In the Matter of)	
)	
AMERGEN ENERGY COMPANY, LLC)	
)	Docket No. 50-0219-LR
(License Renewal for the Oyster Creek)	
Nuclear Generating Station))

**PREFILED SUR-REBUTTAL WRITTEN TESTIMONY OF
DR. RUDOLF H. HAUSLER REGARDING
CITIZENS' DRYWELL CONTENTION**

On behalf of Citizens, Dr. Rudolf H. Hausler hereby submits the following sur-rebuttal testimony regarding Citizens' contention.

Figure 1

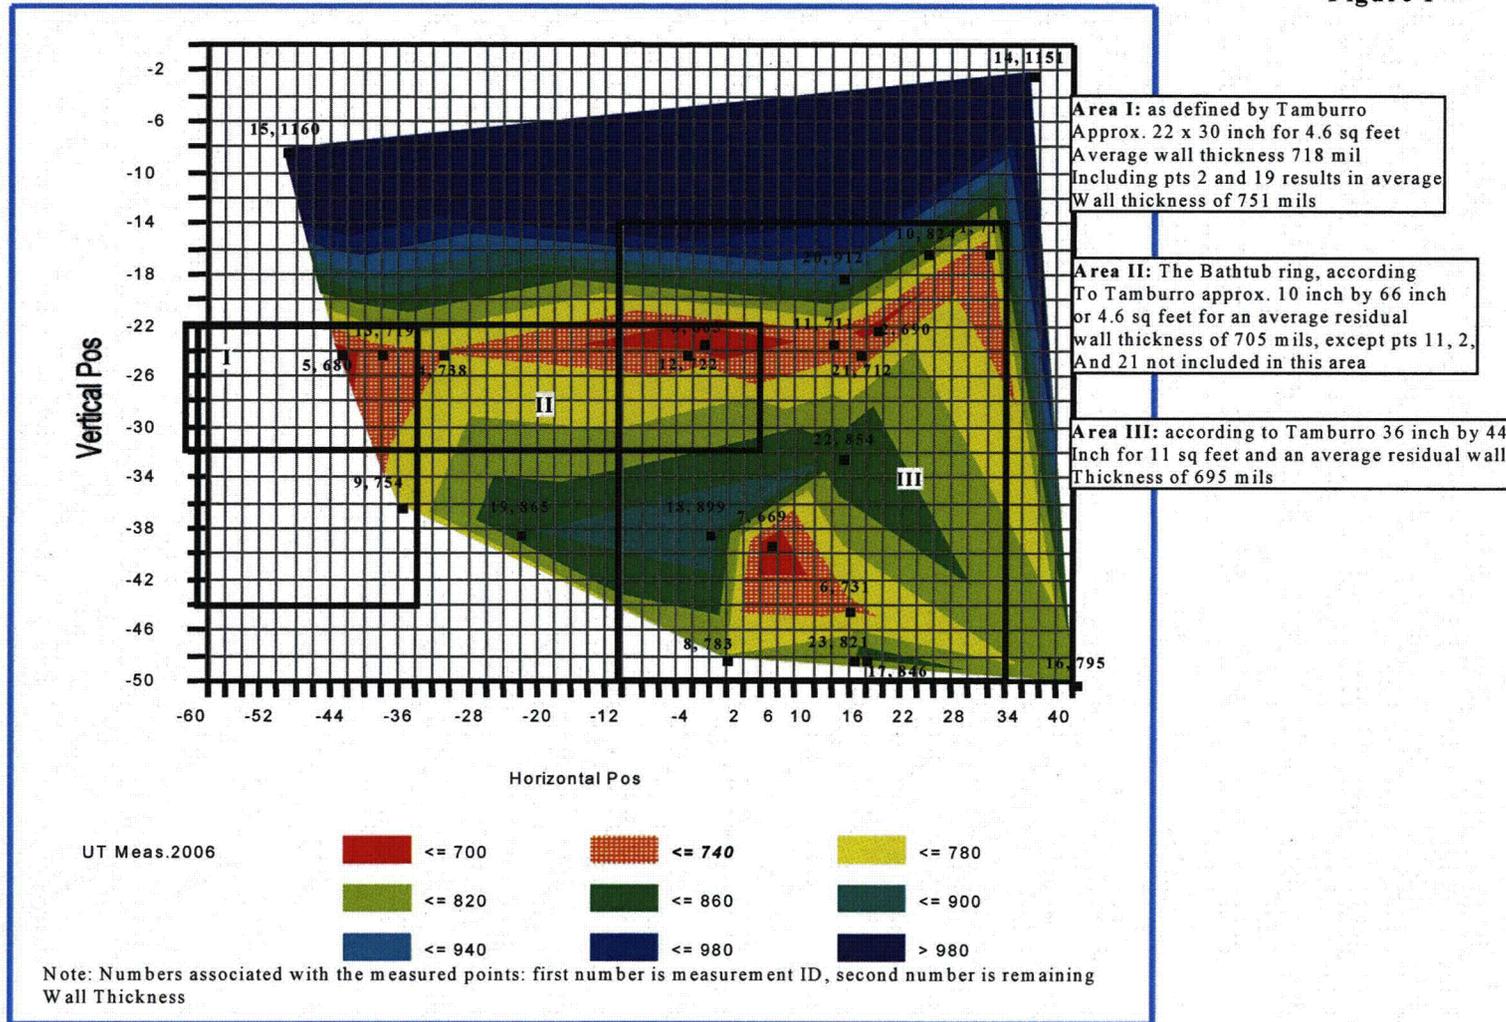
Bay 1 Contour Plot for 2006 External Measurement Data
 Individual Evaluation Areas from Tamburro Analysis superimposed [see Calc. 24 Rev. 2 Fig. 2-1]

Figure 4

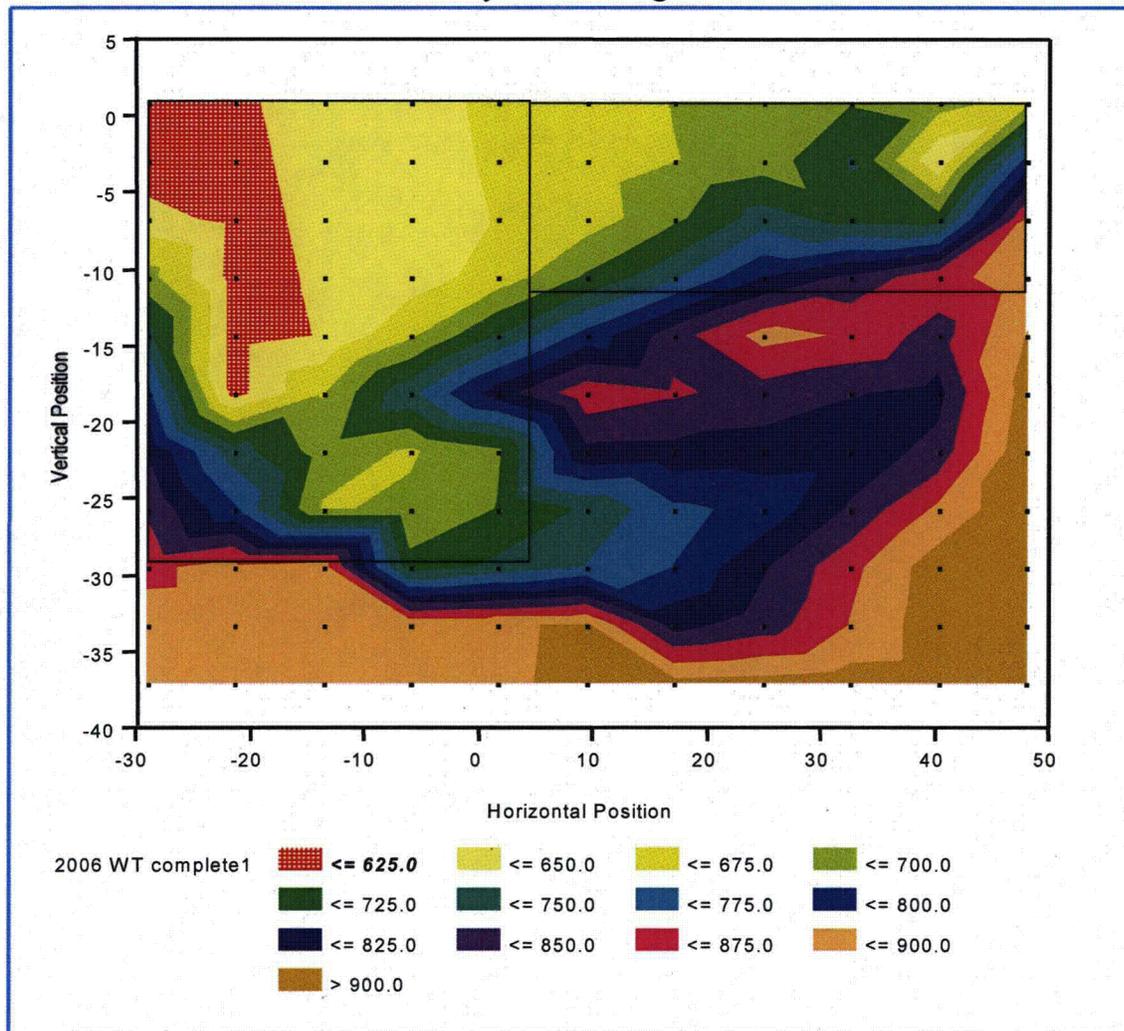
Predicted Response Surface for area of Bay 13
 Contiguous Areas which are less than 725 mils about 12 sqft
 Bordered by the dark green areas.
